## REPORT OF ALTERATIONS TO DESIGNATED RESOURCE

Site Number/Address: 511 Whedbee Street

Laurel School National Register Historic District

ISSUED: September 30, 2021

**Historic survey image of the property from 1994:**

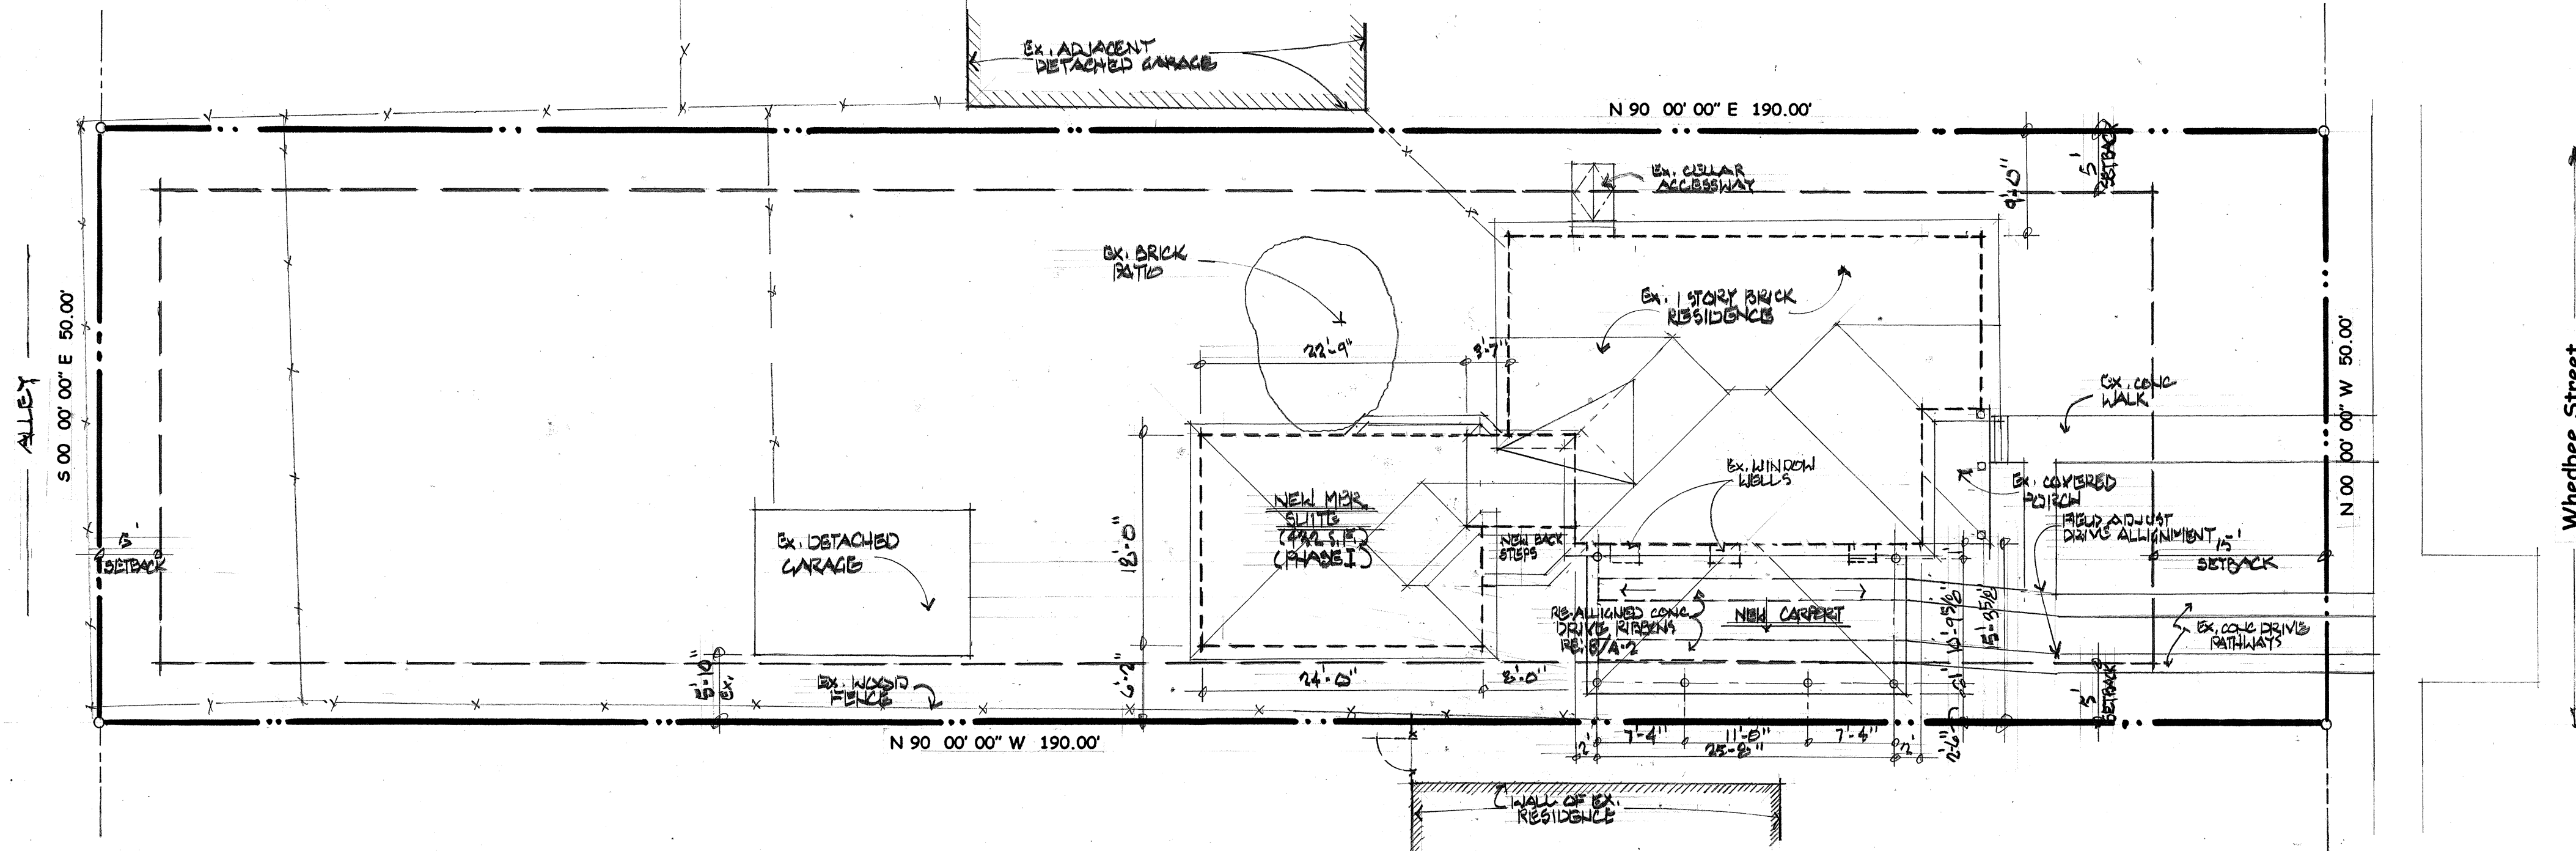
occupant in 1904. However, shortly thereafter, Georgia A. McKibben, a widow, is listed as residing at the property, suggesting Hutchinson was a renter. Character-defining features of the property include its small, Queen Anne/Edwardian design, hipped gable-ell roof form, brick exterior walls, wood windows, and a wood frame porch in the gable ell with simple Doric columns.

Building Elevations

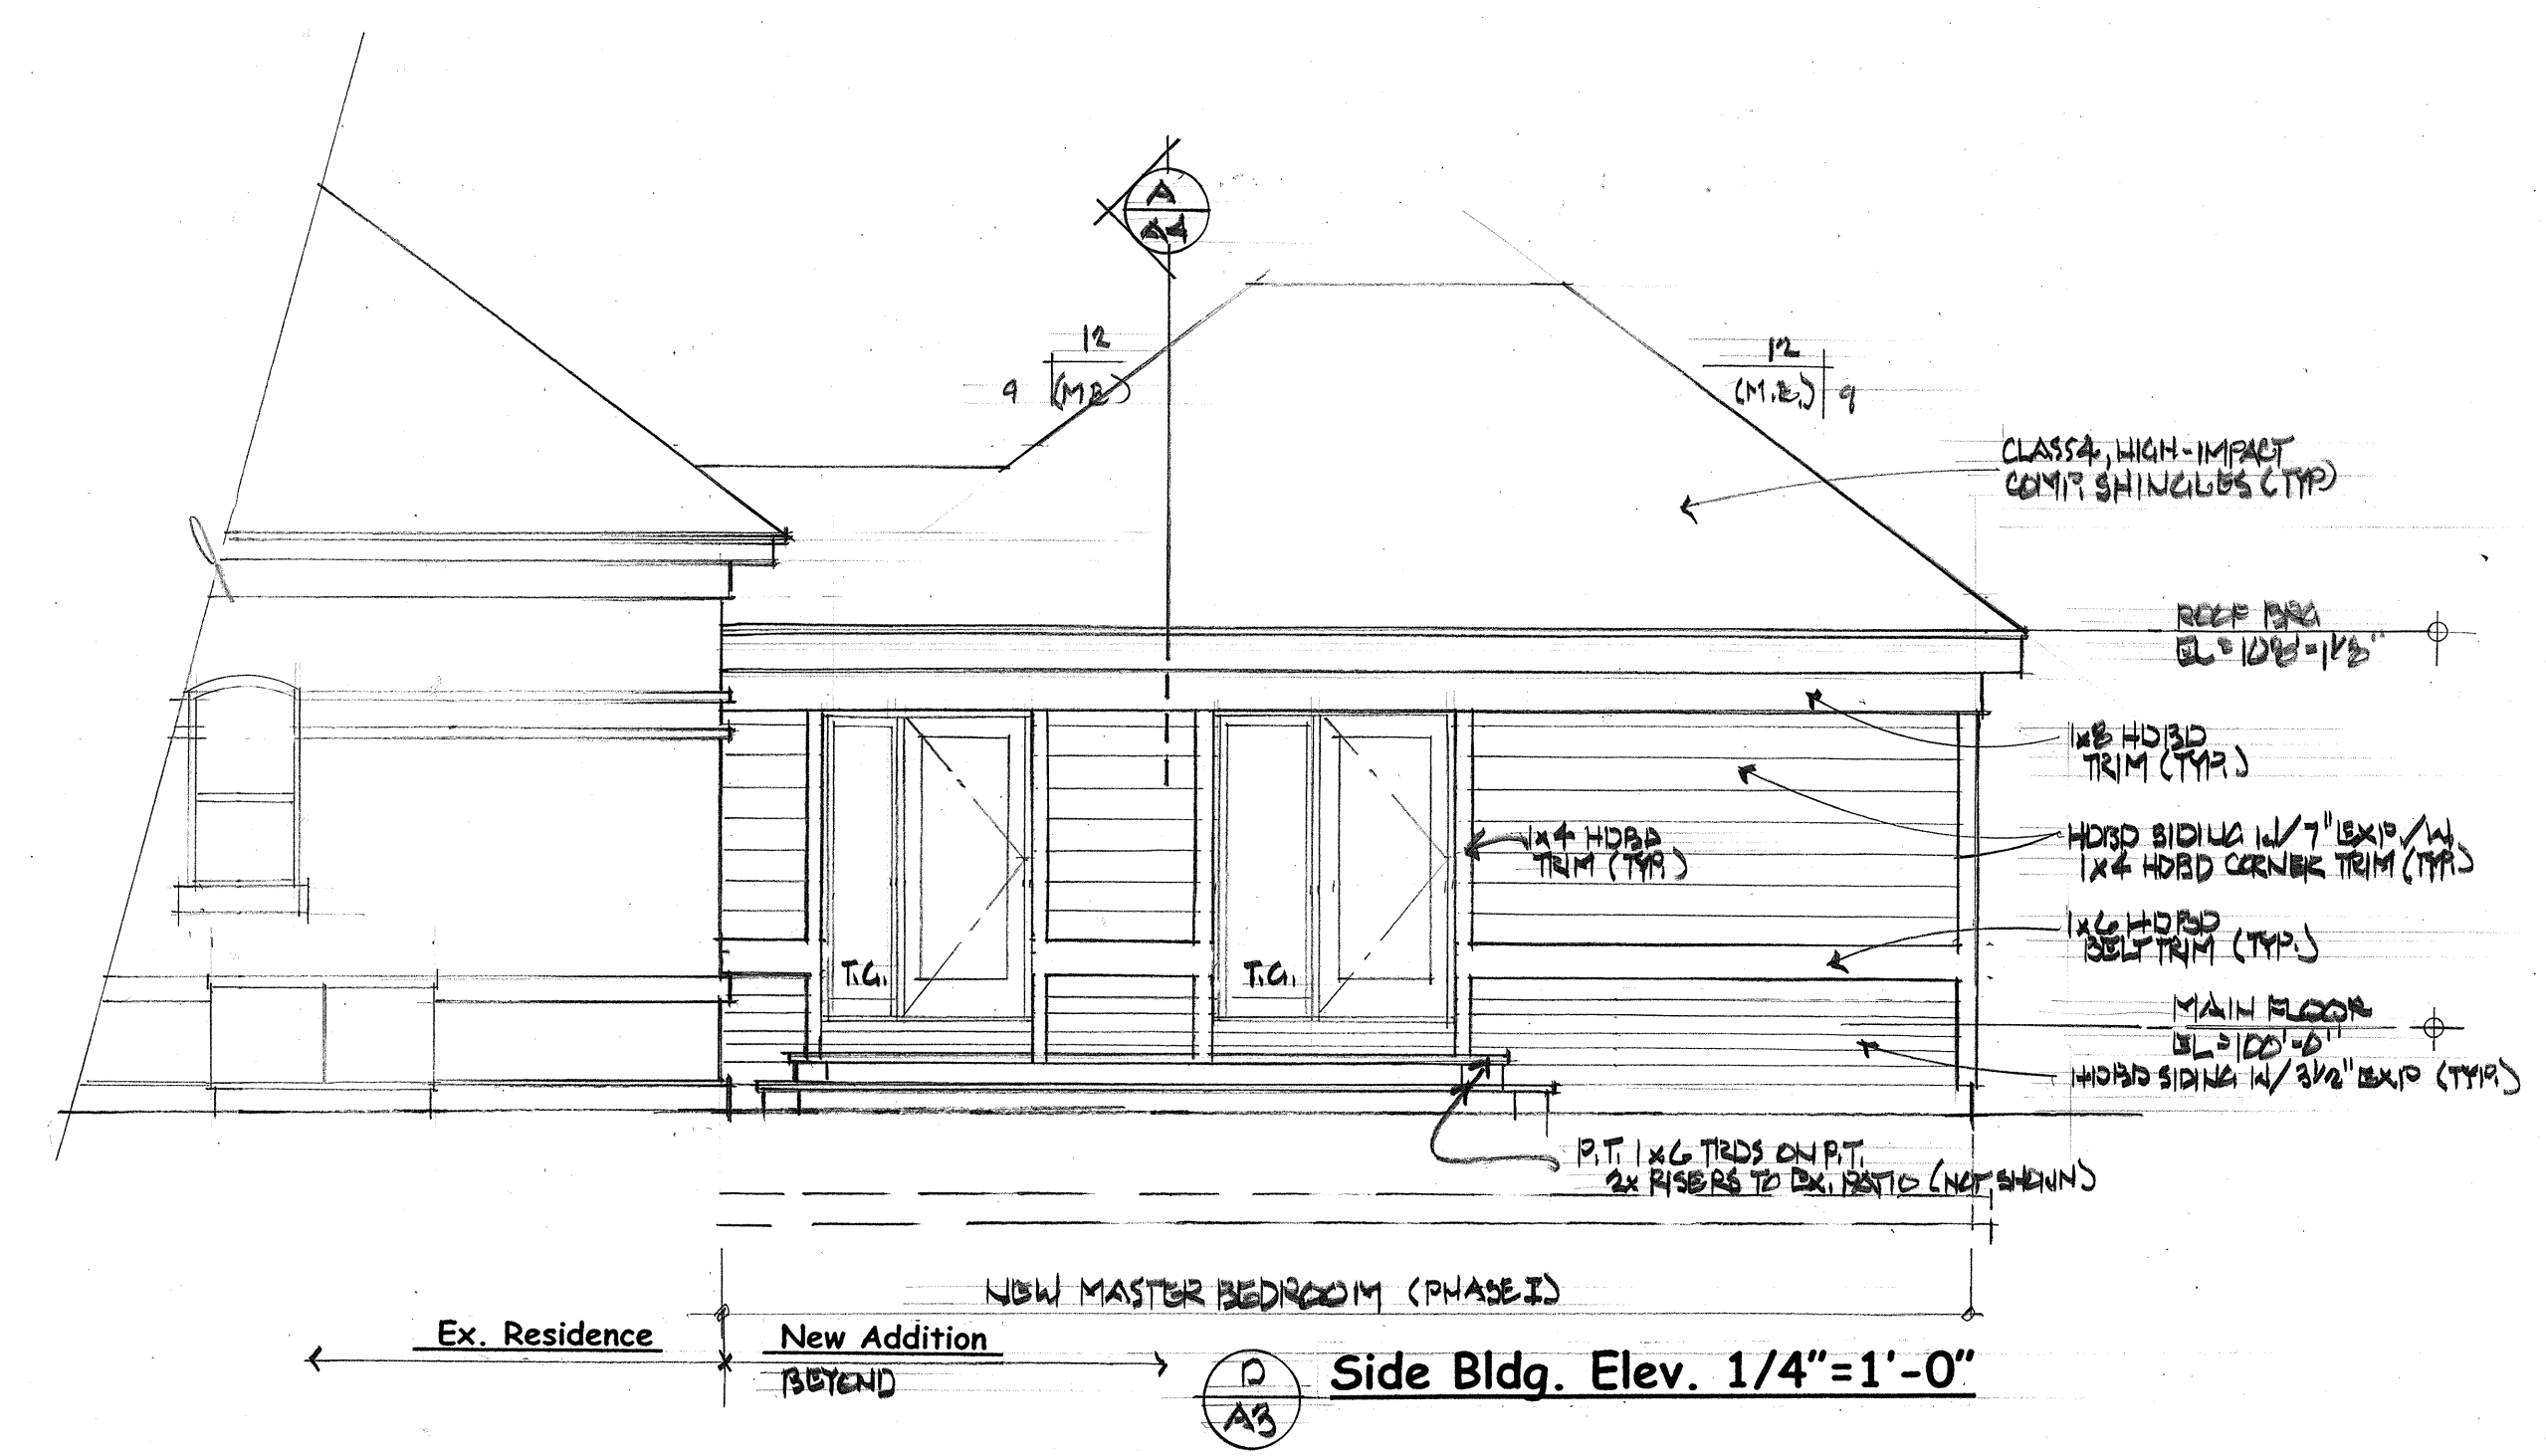
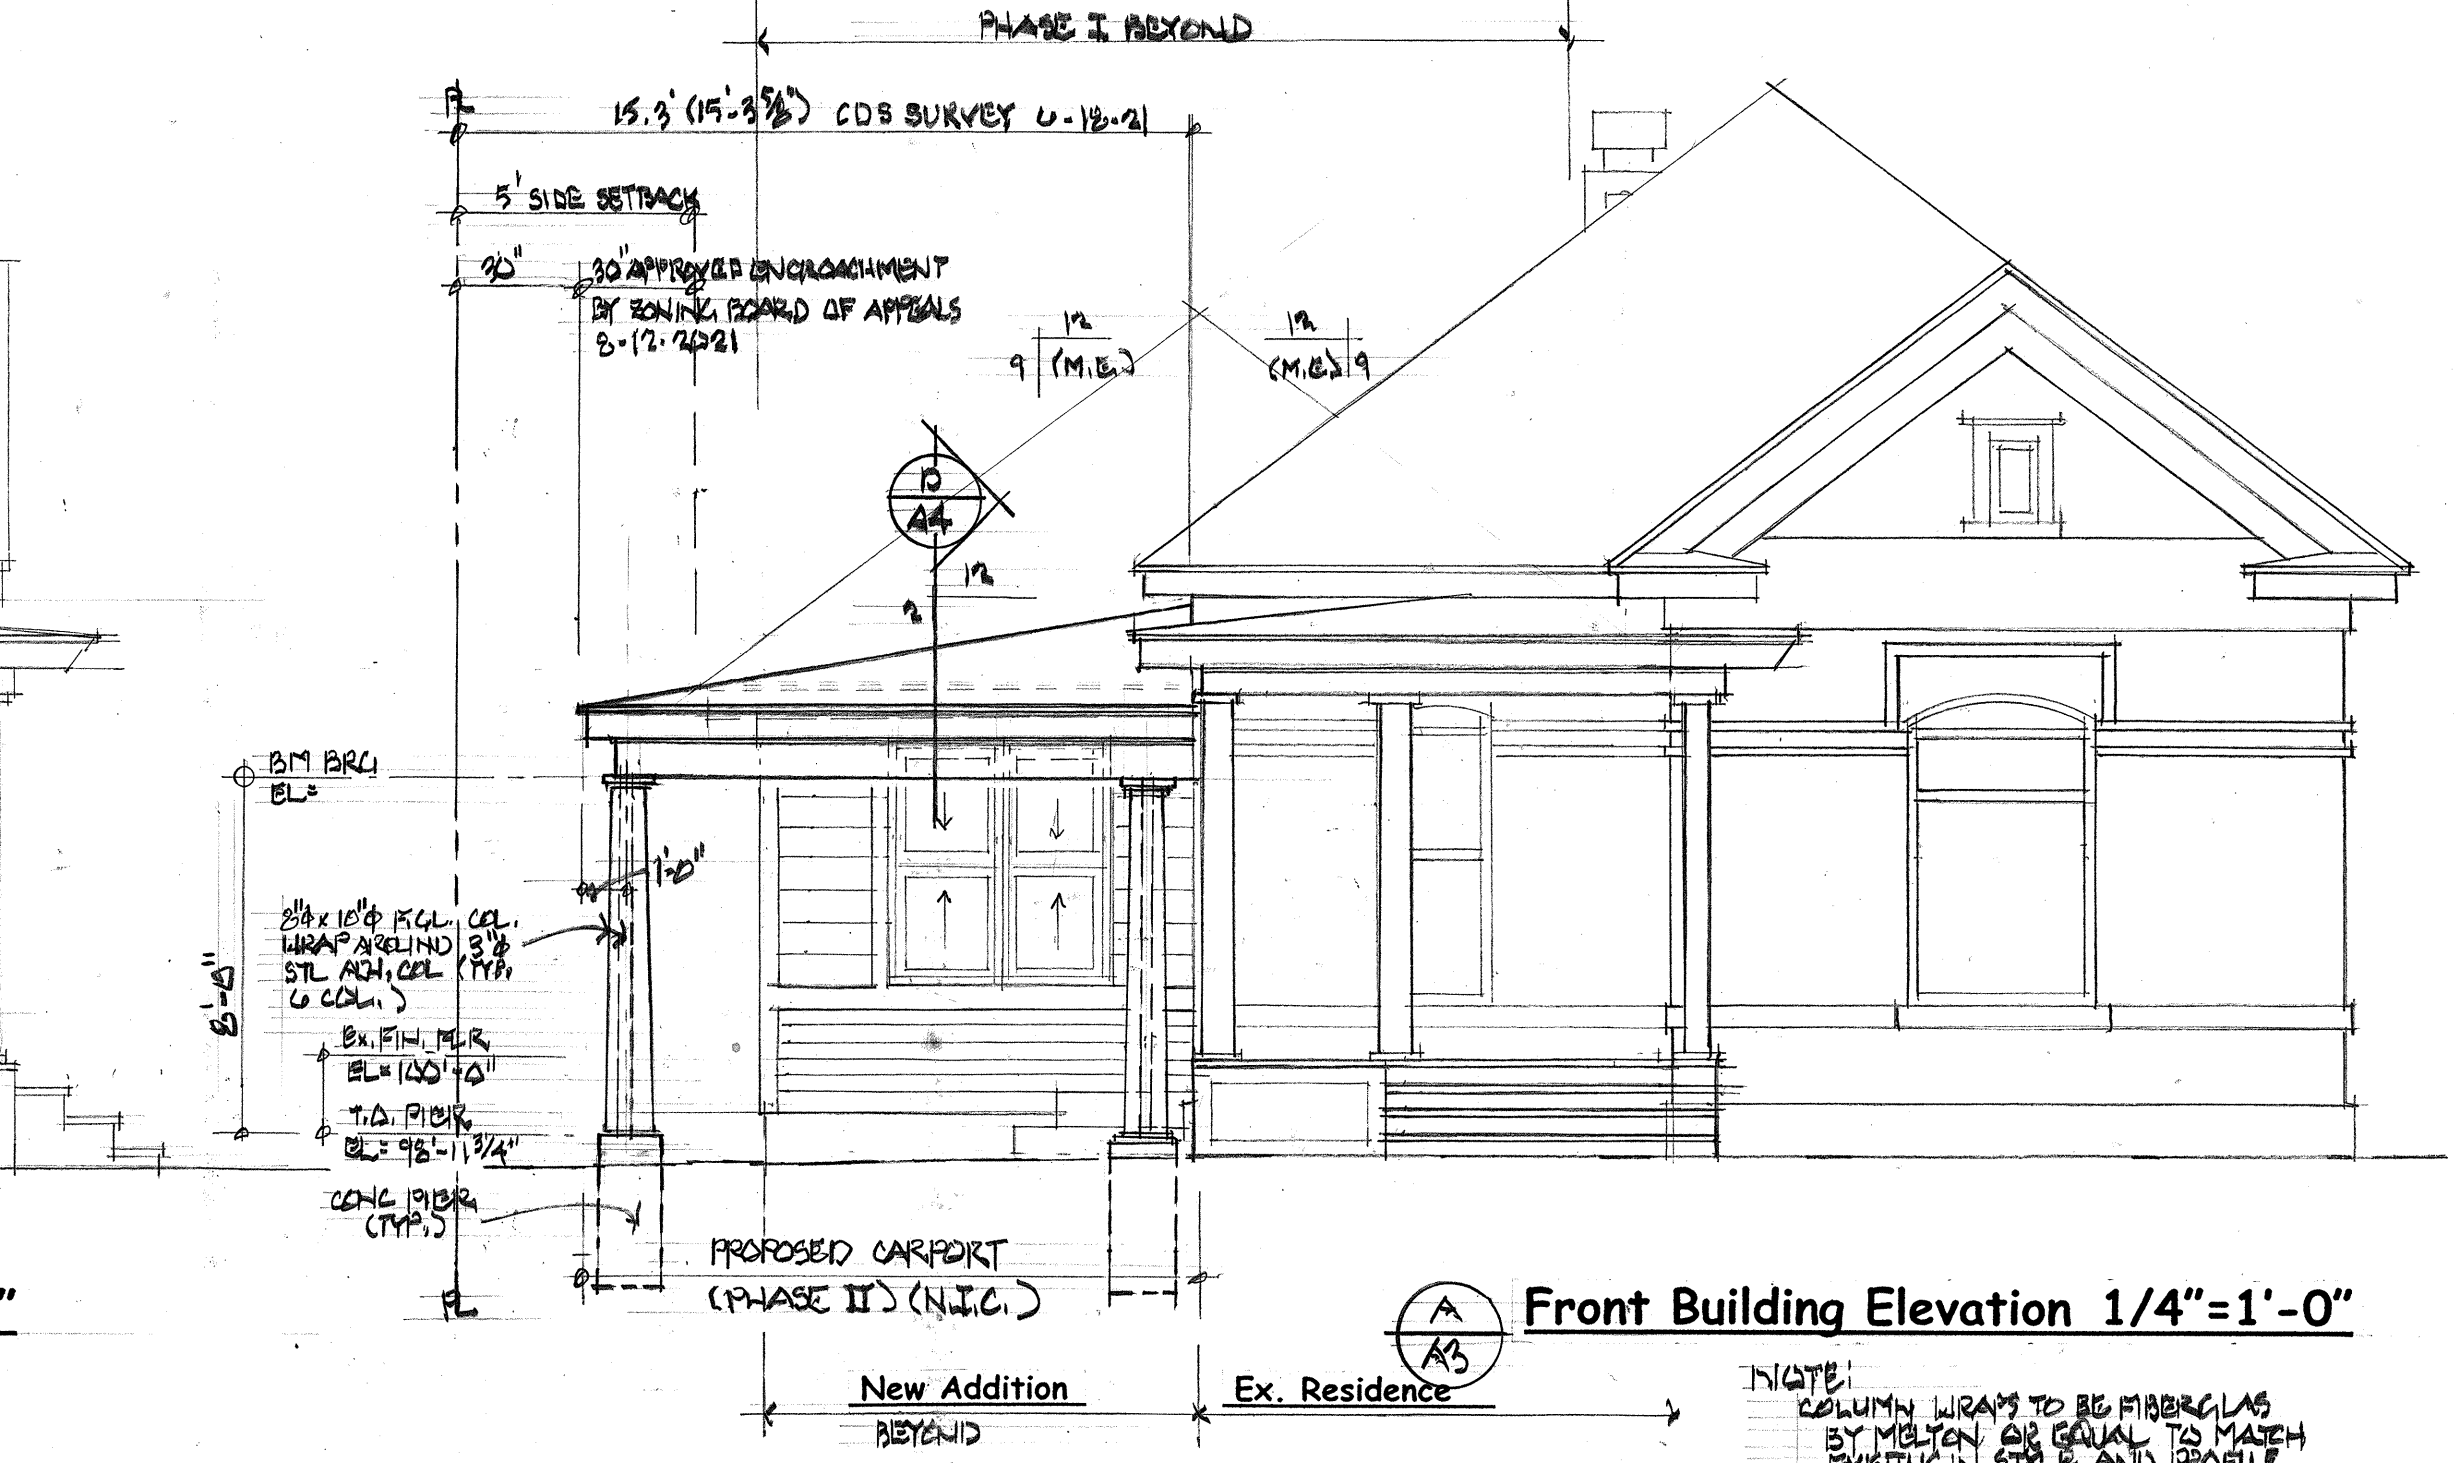
**Carport –** This modification does not meet this Standard. While porte cochere's were seen during the historic district's period of significance (c.1880-1940), they were highly uncommon in Fort Collins, even on residences for wealthier residents, because alley side garages and carriage houses were much more common ways to store wagons, carriages, and vehicles. The highly visible addition of a carport to the home's south elevation will disrupt the overall character of the property. It is not resulting in the removal of any historic features but will be highly noticeable and disrupt the simple design of the property as viewed from Whedbee Street.

<p><b>Carport – The carport addition onto the south elevation does not meet this Standard.</b></p> <ul style="list-style-type: none"> <li>- <b>Compatibility – the carport addition is not compatible with the overall design of the property. Carport/porte cochere features were almost never installed on homes of this size and type, and especially not in Fort Collins.</b></li> <li>- <b>Distinguishability – the carport addition further is not properly distinguishable as a new feature, creating a false sense of historical development through the use of Classical columns to support the feature.</b></li> <li>- <b>Subordination – In a residential context, side additions of any kind are generally discouraged under the Standards. In this case, the carport will extend to the front wall plane of the property and will be highly visible from Whedbee Street – it does not meet this Standard.</b></li> </ul>
